**Project Level Particulate Matter (PM10)
Consultation Document**

**El Mirage Road
SR 303L – Jomax Road**

**FHWA Project No. PEO-0(231)T
ADOT Project No. 0000 MA PEO T0428 01D**

3.18.25 EPA Comments on Draft Consultation Documents & Modeling Files

Figure 3. PM Links and Receptors Placement for Air Quality Modeling
 (El Mirage Road and SR 303L WB&EB Ramp)

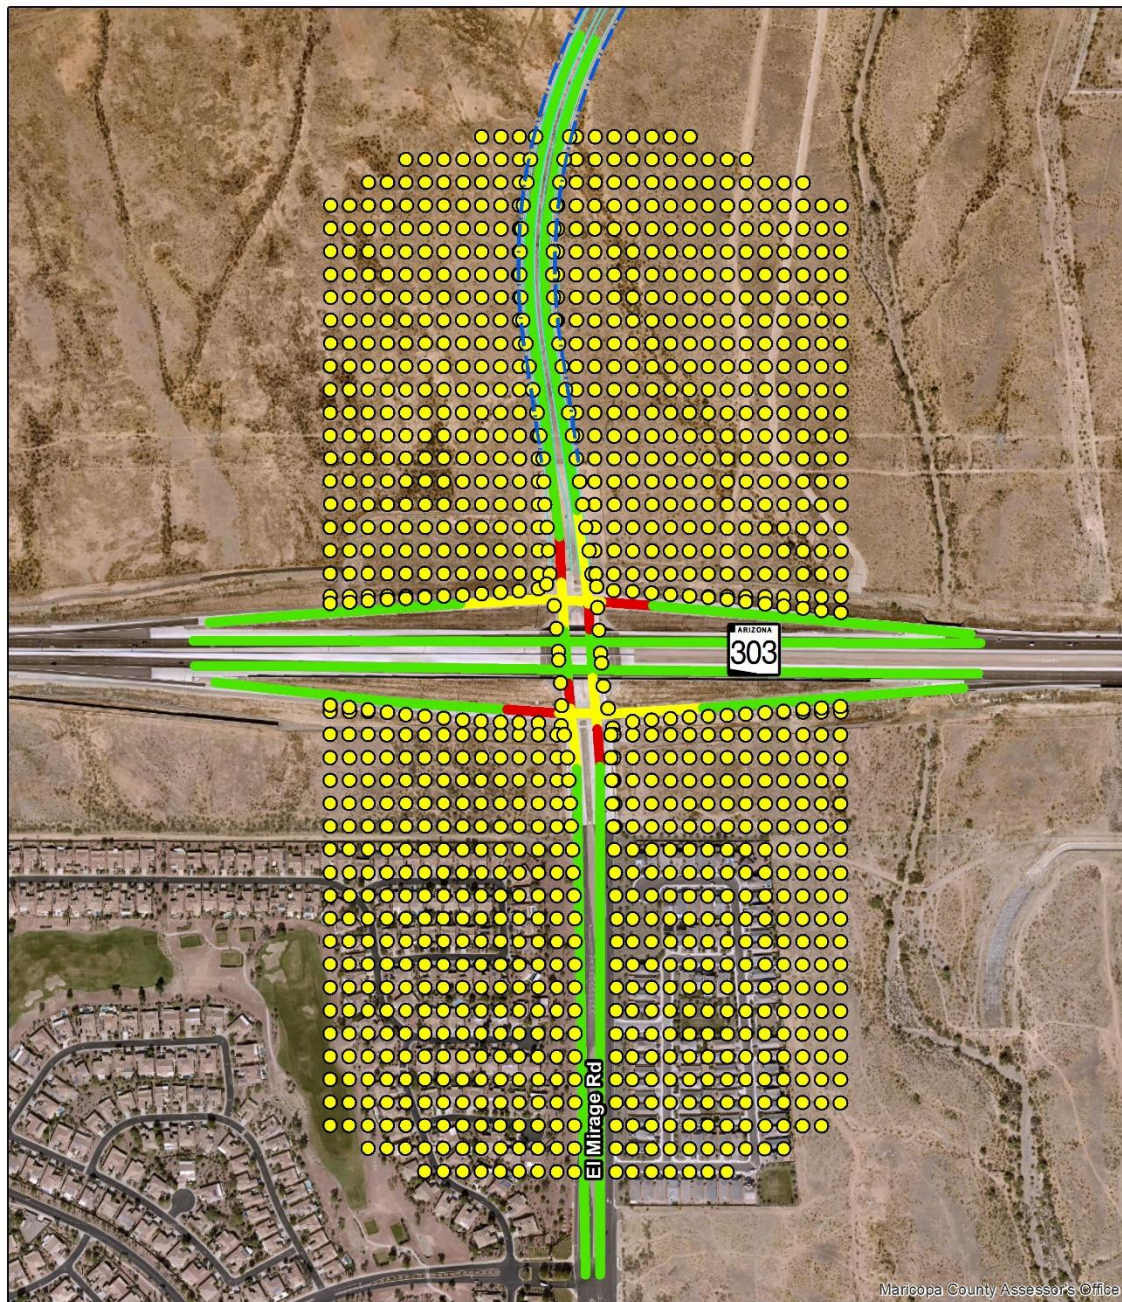
For SR303 WB Ramp intersection, the highest PM concentration would occur on the El Mirage sidewalk under SR303 mainline, which is approximately 28 ug/m³. The PM concentration along the El Mirage Rd 1500 feet north of SR303 WB Ramp intersection would decrease to approximately 8 ug/m³, much less than that on the intersection sidewalk area.

Figure 1. PM Links and Receptors Placement for Air Quality Modeling
(El Mirage Road and Jomax Road)

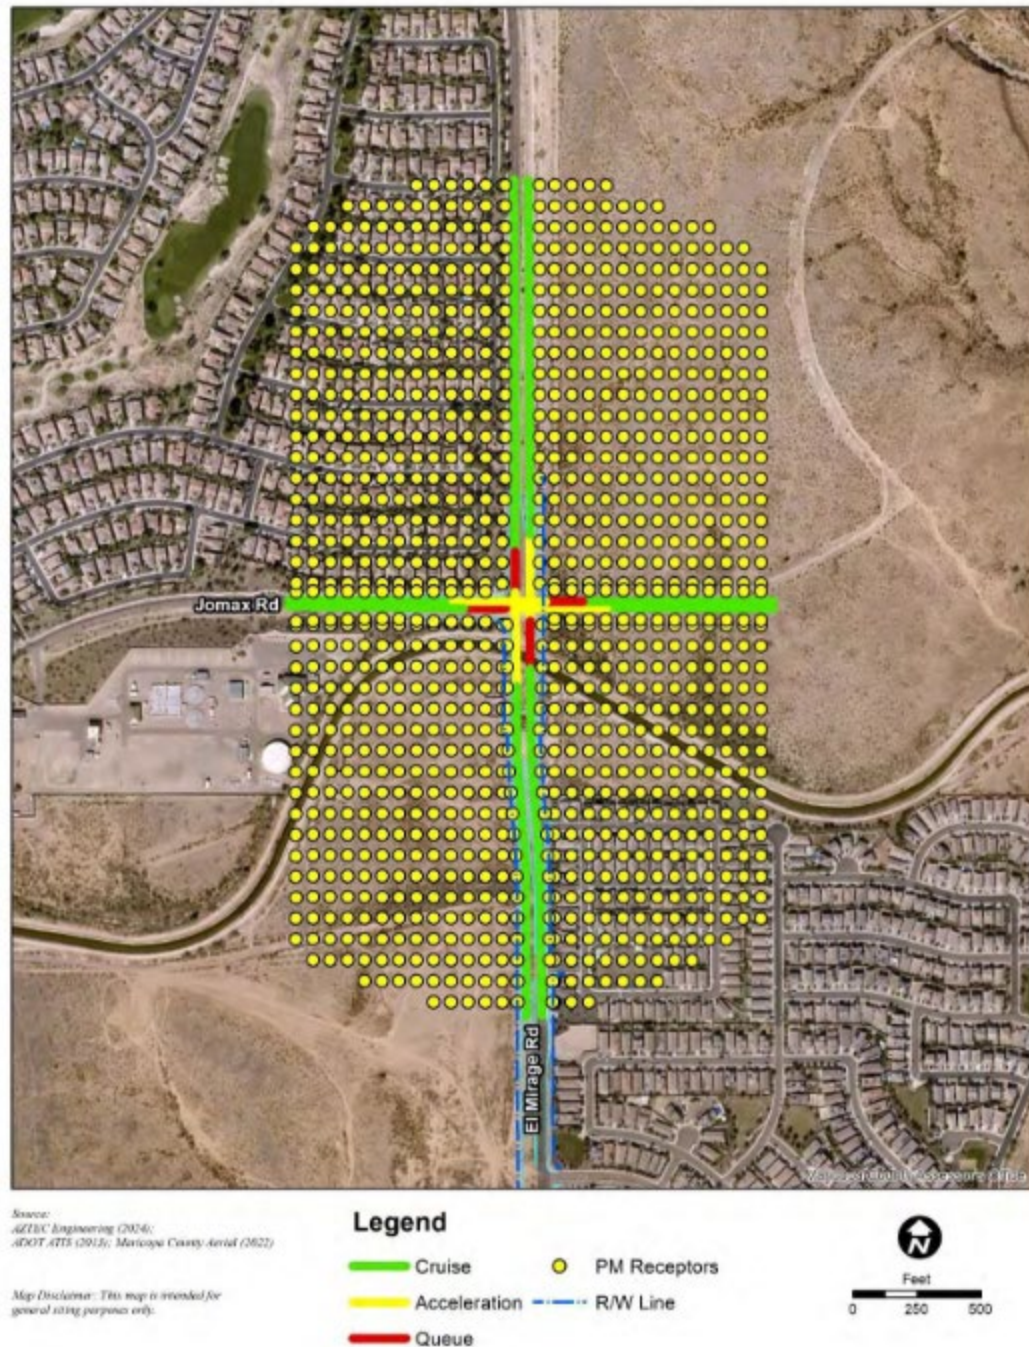
10. Pg 17 – For the Jomax/El Mirage area, why are receptors and sources not considered for the southern part of the interchange?

Response: As discussed earlier, it can be inferred that lower PM emissions concentrations would result along the middle section of the freeway/arterial mainline between adjacent two interchanges/intersections. This is mainly because high PM concentrations normally occur adjacent to the intersections due to greater traffic volumes, worse LOS and delay, and close proximity to public (like intersection corner or cross street sidewalk).

For Jomax Rd intersection, the highest PM concentration would occur on the intersection sidewalk area at the northwest corner, which is approximately 20 ug/m³. The PM concentration at southern part of the intersection would decrease to approximately 10 ug/m³, much less than that on the intersection sidewalk area.
